Agenda Item # 7

SUB-003757-2026

Sunrise Prayer House Subdivision

- Subdivision approval to create one (1) legal lot of record from a metes-and-bounds parcel.

DETAIL SITE PLAN

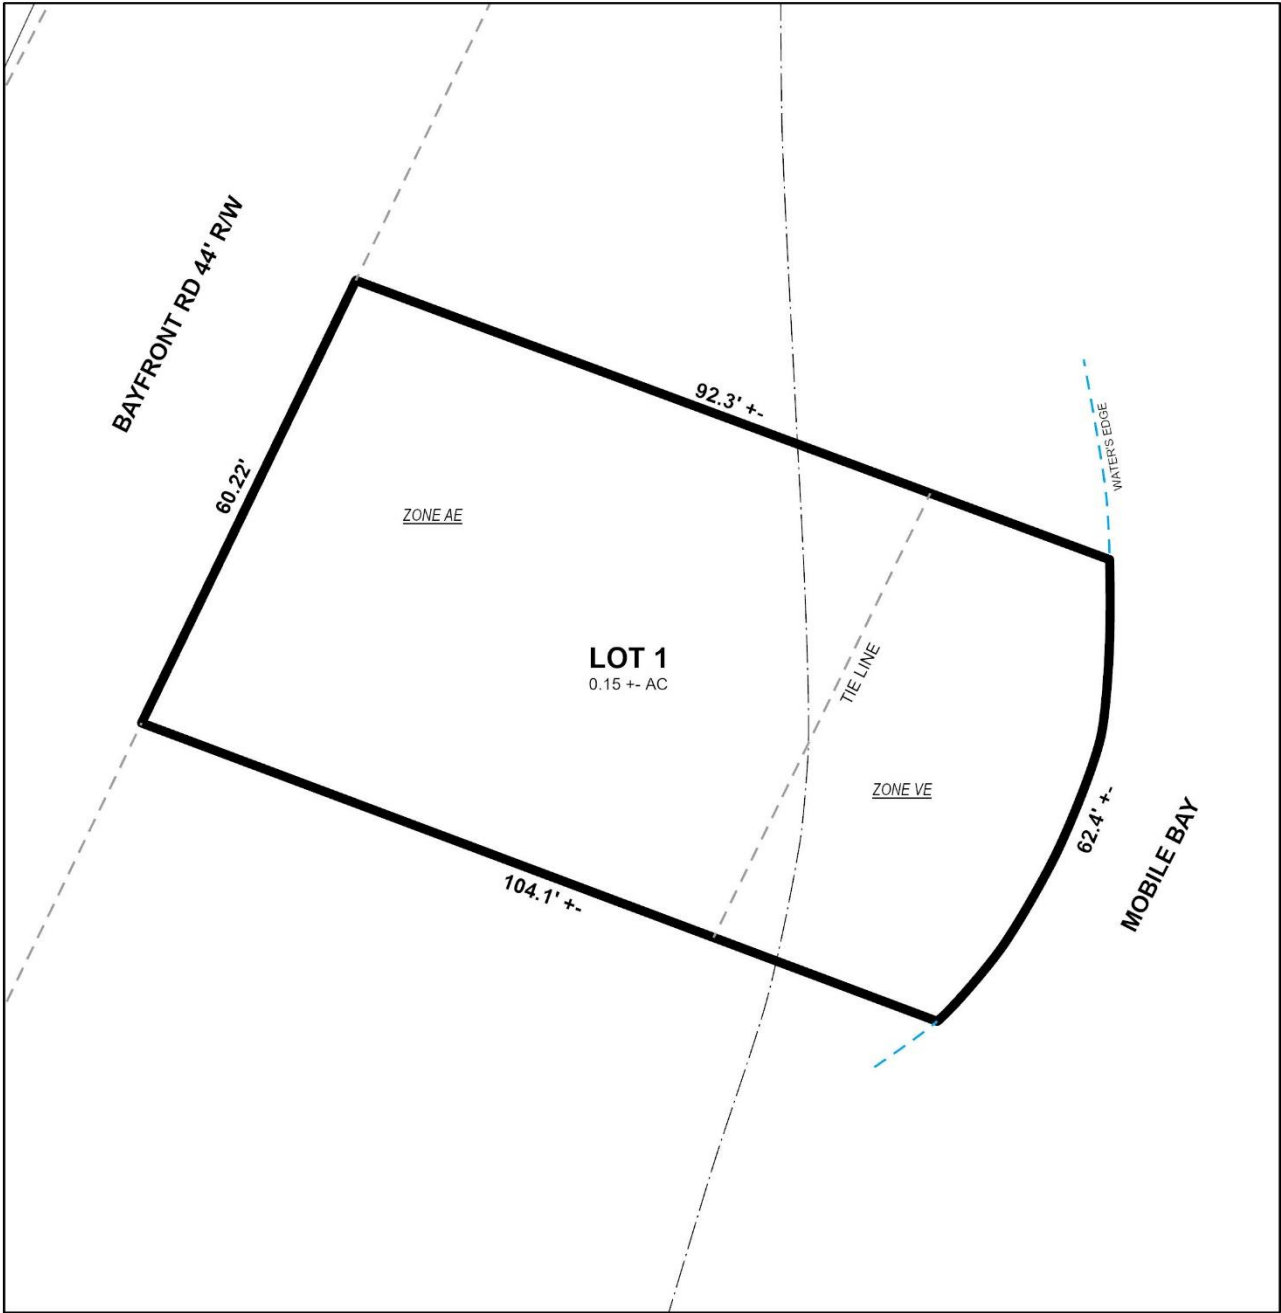
The proposed lot has frontage along Bay Front Road, a minor street without curb and gutter requiring a 60-foot-wide right-of-way at this location. Sufficient right-of-way is not depicted along Bay Front Road on the preliminary plat, making additional dedication necessary. If approved, the plat should be revised to illustrate dedication sufficient to provide 30 feet from the centerline of Bay Front Road, unless a waiver of Section 6.B.9. of the Subdivision Regulations is recommended by the City Engineer and Traffic Engineer.

The proposed lot meets the minimum width requirements of Section 6.C.2.(b)(2) of the Subdivision Regulations for Residential Suburban Districts. The lot does not meet the minimum area requirements of Article 2, Section 64-2-5.E. of the Unified Development Code (UDC) for lots served by public water and sanitary sewer within the R-1, Single-Family Residential Suburban District. As such, a waiver of Section 6.C.2.(a)(1)a. of the Subdivision Regulations will be necessary for approval.

If approved, the plat should be revised to illustrate a 25-foot front yard setback along Bay Front Road, in accordance with Article 2, Section 64-2-5.E. of the UDC and Section 6.C.8. of the Subdivision Regulations, adjusted for any required dedication.

Finally, the property is located within the AE flood zone and is subject to flooding. Pursuant to Section 6.A.3. of the Subdivision Regulations, development in flood-prone areas must comply with all applicable local, state, and federal regulations. This may necessitate elevating any future structures. It should also be noted that the UDC limits building height in the R-1 Suburban District to 35 feet, measured from grade. Any structure requiring additional height to meet elevation requirements would necessitate approval of a Height Variance from the Board of Zoning Adjustment.

1. Revision of the plat to illustrate dedication sufficient to provide 30 feet from the centerline of Bay Front Road, unless a waiver of Section 6.B.9. of the Subdivision Regulations is recommended by the City Engineer and Traffic Engineer;

2. Retention of the lot's size in both square feet and acres, adjusted for any required dedication, or the provision of a table on the Final Plat providing the same information;

3. Revision of the Final Plat to illustrate the required 25-foot front yard setback along Bay Front Road, in compliance with Article 2, Section 64-2-5.E. of the UDC and Section 6.C.8. of the Subdivision Regulations, adjusted for any required dedication;
